Sent: 27/05/2020 2:48:53 PM
Subject: Attention Development Assessment : DA2020/0393 28 Lockwood Ave Belrose
Attachments: DA2020_0393_Submission.pdf;

Re: Application DA2020/0393
28 Lockwood Ave Belrose, 2085

Description: Demolitions works and construction of a shop top housing development comprising retail premises, 51 dwellings, gym, basement car-parking and landscaping
To Mr Cocks,

Figure 1- setbacks on Lockwood Ave, existing and development proposed

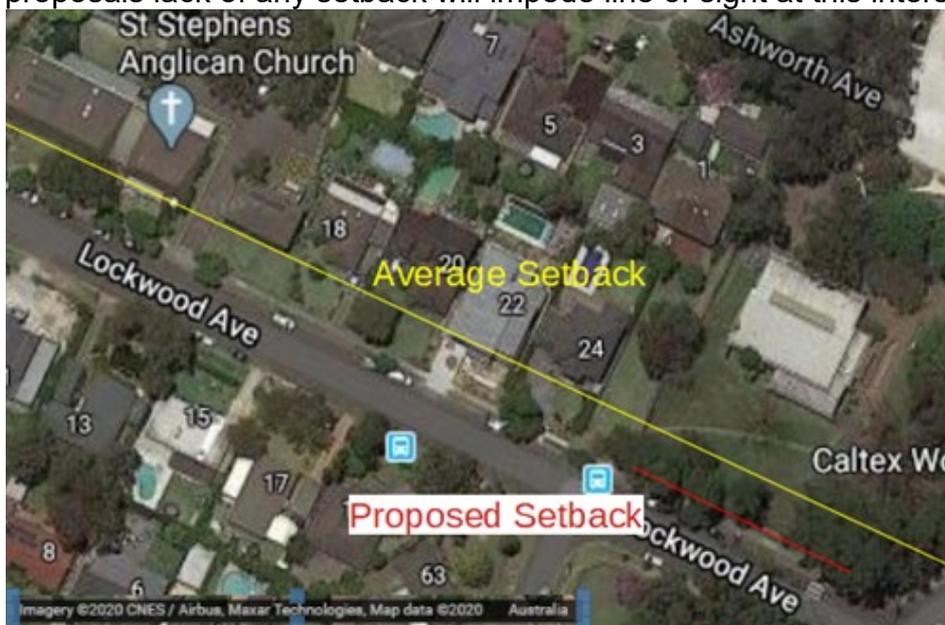
The setback on Lockwood Ave **does not align** with existing structures in the street. The average setback for Northern side on Lockwood Ave is 13.5 metres (approx.), see Figure 1. The development has no setback on Lockwood Ave and is replacing open space which provides a clear line of sight and a safe shared space with narrow retail street frontage. The risk of vehicle and pedestrian or cyclist accidents will increase at the Lockwood Ave and Glen St intersection with the lack of an appropriate setback. The existing open space and setback provides vehicles turning right from Glen St into Lockwood Ave with early and good visibility of the pedestrian crossing on and vehicles heading south along Lockwood Ave. The proposals lack of any setback will impede line of sight at this intersection.

Figure 3 – Change to pedestrian desire lines

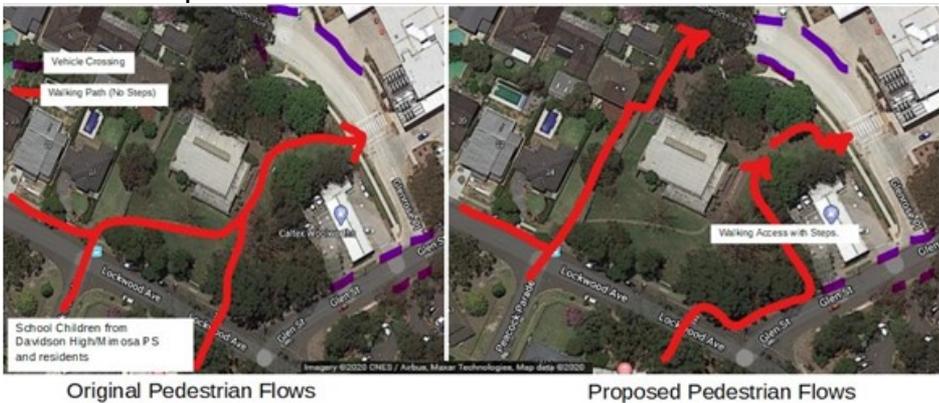
The pedestrian desire lines from the south and west to GSV are **redirected around the development**. The previous paths were direct, safe and stair free. School children and others use the low traffic Peacock Parade as the major walking and cycling route between Davidson High School and Mimosa Public School to the GSV.

The development will direct journeys from South and West down the Western edge of development increasing risks of accidents between pedestrian and vehicles at the entry to GSV via car-park drive.

Figure 1- setbacks on Lockwood Ave, existing and development proposed

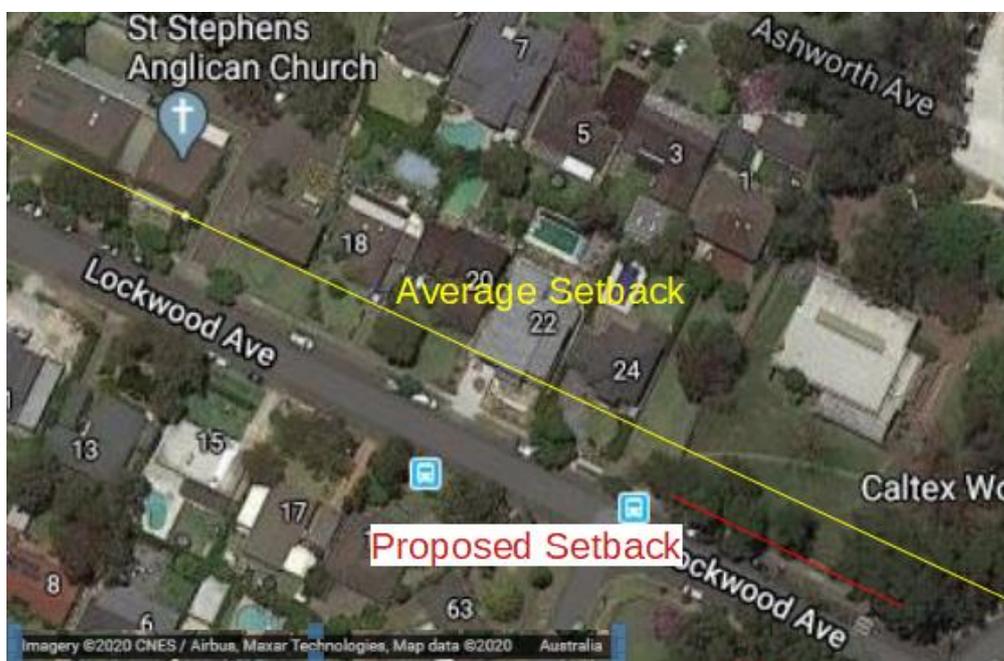
The setback on Lockwood Ave **does not align** with existing structures in the street. The average setback for Northern side on Lockwood Ave is 13.5 metres (approx.), see Figure 1. The development has no setback on Lockwood Ave and is replacing open space which provides a clear line of sight and a safe shared space with narrow retail street frontage.

The risk of vehicle and pedestrian or cyclist accidents will increase at the Lockwood Ave and Glen St intersection with the lack of an appropriate setback. The existing open space and setback provides vehicles turning right from Glen St into Lockwood Ave with early and good visibility of the pedestrian crossing on and vehicles heading south along Lockwood Ave. The proposals lack of any setback will impede line of sight at this intersection.

Figure 2 - best practice setback for 'Active Street' frontages

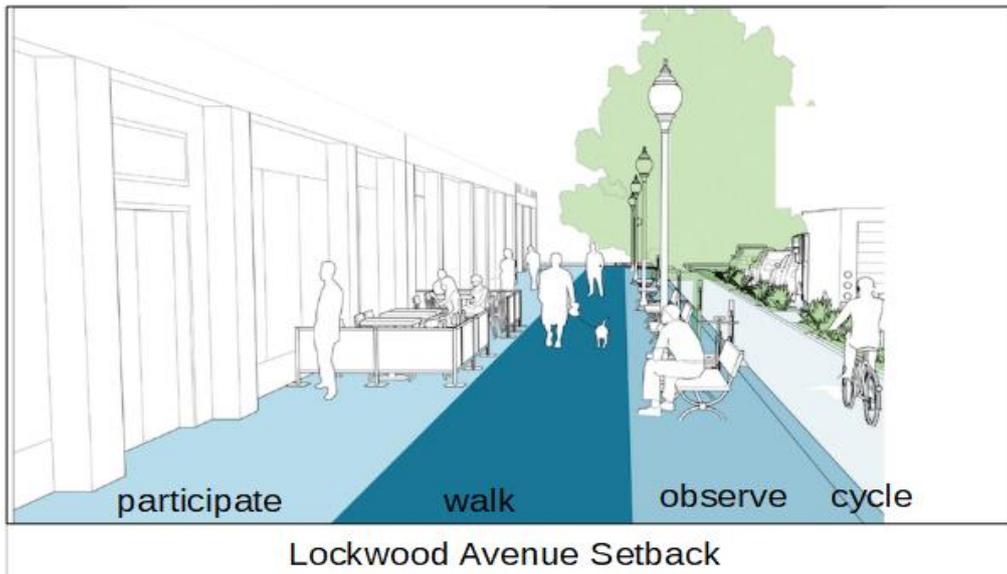
To increase the attractiveness of walking and cycling and safety on Lockwood Ave and Glen St a wide shared path is required for locals to walk, cycle, observe and participate (see Figure 2) and the pedestrian crossing on Lockwood Ave should be upgraded to a raised wombat crossing with wide drop kerbs to improve safety and pedestrian and cyclist amenity.

Figure 3 – Change to pedestrian desire lines

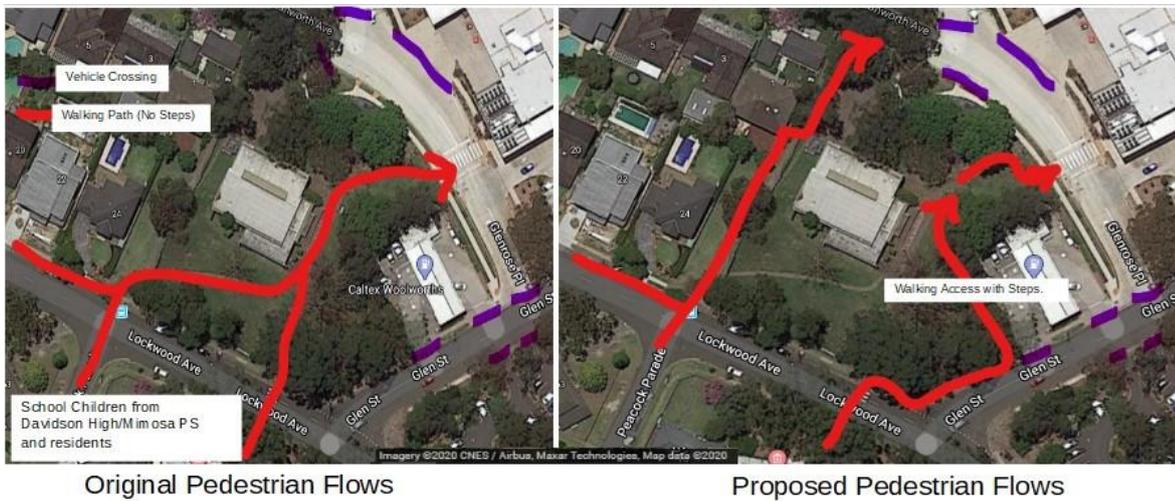
The pedestrian desire lines from the south and west to GSV are **redirected around the development**. The previous paths were direct, safe and stair free. School children and others use the low traffic Peacock Parade as the major walking and cycling route between Davidson High School and Mimosa Public School to the GSV.

The development will direct journeys from South and West down the Western edge of development increasing risks of accidents between pedestrian and vehicles at the entry to GSV via car-park drive.
